Group 12  
Engine Electrical Systems

Bulletin Number  
12 10 99

SUBJECT:  
Voluntary Emissions Recall Campaign No. 99E-A01

MODEL:  
E36 - 323i and 328i with M52 engine produced 6/95 - 12/98  
E36 - M3 with 852 engine produced 1/96 - 12/98  
E39 - 528i with M52 engine produced 3/96 - 8/98  
Z3 - with M52 engine produced 7/96 - 9/98  
Z3 - with 852 engine produced 1/98 - 1/99

Correction:

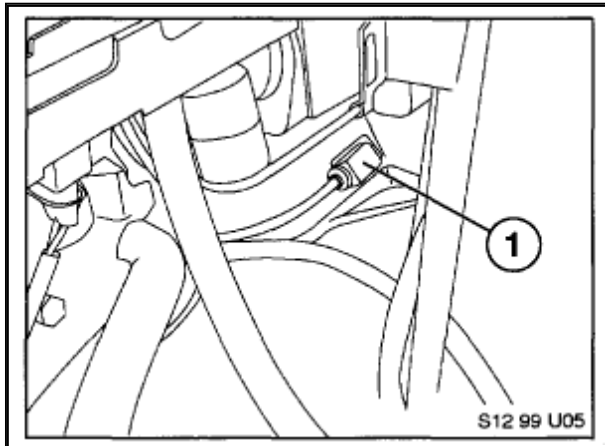
The crankshaft position sensor needs to be replaced with the same type of sensor that is currently being used on the M52TU engine. Along with replacing the sensor an adapter harness must also be installed in order to supply the sensor with a 12V operating voltage instead of the 5 volts currently being supplied by the DME.

1. Remove the crankshaft position sensor which is located below the starter motor.

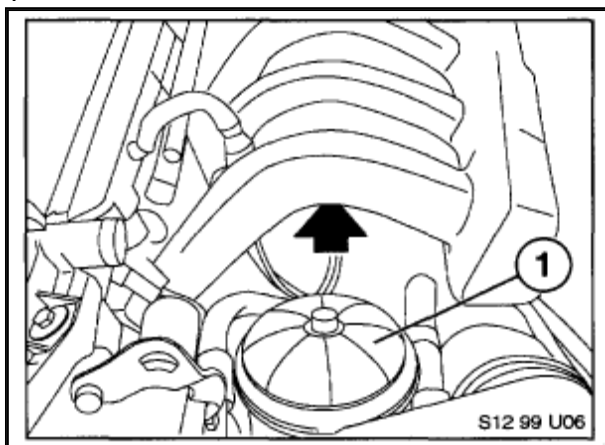
Remove the Sensor (1)

\*\*If the sensor currently installed in the vehicle has a connector directly on the sensor which can be disconnected, then the new sensor is already installed. No further action is required and the DCS contact can be closed.\*\*

2. The electrical connection of the crankshaft sensor to the engine harness is located below the intake manifold.

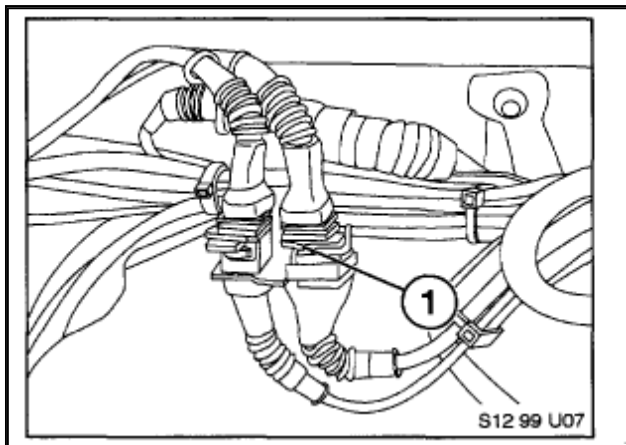
To access this connector, the cap of the oil filter housing (1) should be removed and the oil filter and housing should then be covered to prevent dirt from getting onto the oil filter.

3. Disconnect the crankshaft position sensor (1) from the engine harness.

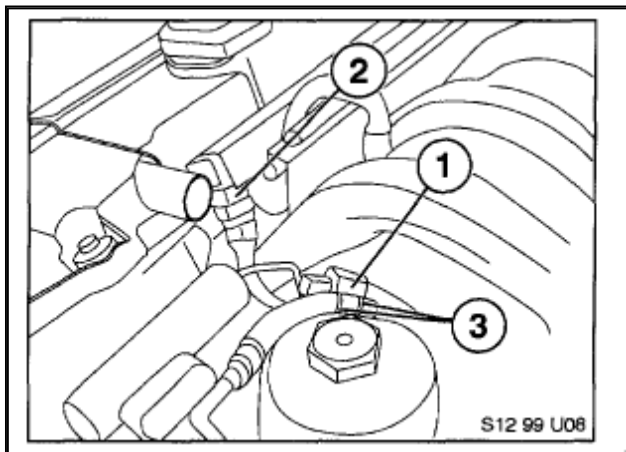
**Note:** This illustration shows the plug connectors with the intake manifold removed. It is not necessary to remove the intake manifold in order to gain access to these connectors and complete this repair.

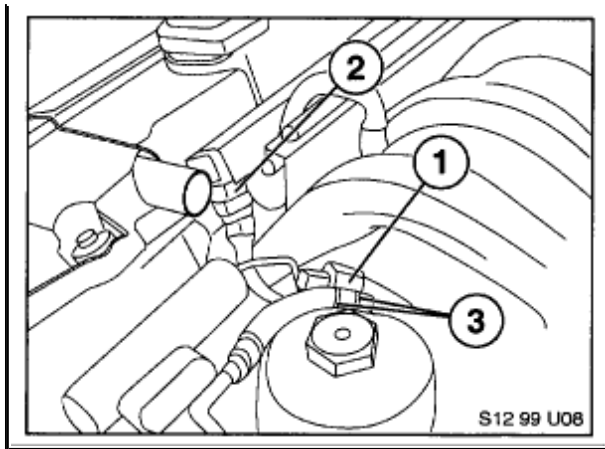
6. Install adapter harness P/N 12 51 4 592 703.
  - a. Connect (1) to the new crankshaft position sensor.
  - b. Connect (2) to the engine harness connector which was previously connected to the old crankshaft sensor located below the intake manifold.
  - c. Connect (3) to the VANOS solenoid valve located on the VANOS unit.
  - d. Connect (4) to the engine wiring harness connector which previously connected directly to the VANOS solenoid valve.
